**Reg. Ref. :** SD21A/0287/C3a-d  
**Proposal :** Extension and alterations consisting of a 2 storey extension at the front main entrance of existing building (371.5sq.m ground floor addition & 367.5sq.m first floor addition); the extension will match the existing mansard roof profile; reorganisation of the first floor over an area of 272.2sq.m with the addition of 9 dormer windows; all associated services connections and ancillary site works.

**Condition 3 a - d:**

**Location :** Kiltipper Woods Care Centre, Kiltipper Road,  
Bohernabreena, Dublin 24, D24A248  
**Applicant :** Stanford Woods Care Centre Ltd.  
**Application Type:** Compliance with Conditions

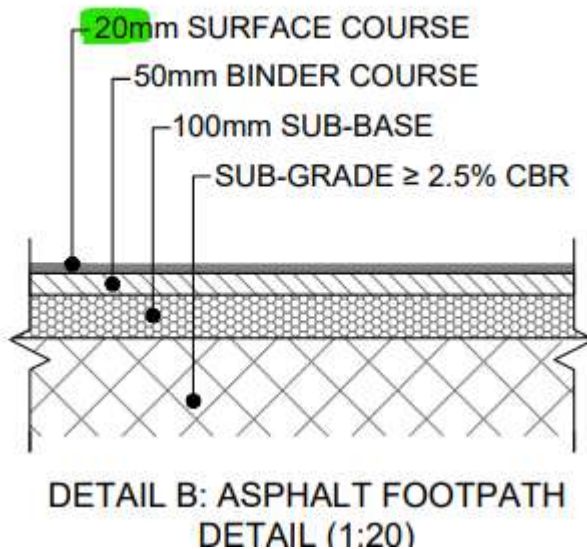
*(c) a revised access site layout plan drawing showing a 1.5m wide advisory cycle lane from the Kiltipper Road to the Dodder Greenway entrance gate unless otherwise agreed with the Planning Authority. A section drawing should also be included showing dimensions of the advisory cycle lane, the overall carriageway width and footpath width at three locations along the access road into the development.*

**Assessment of Compliance Submission for Compliance with Condition:**

*Condition 3(c) has been met.*
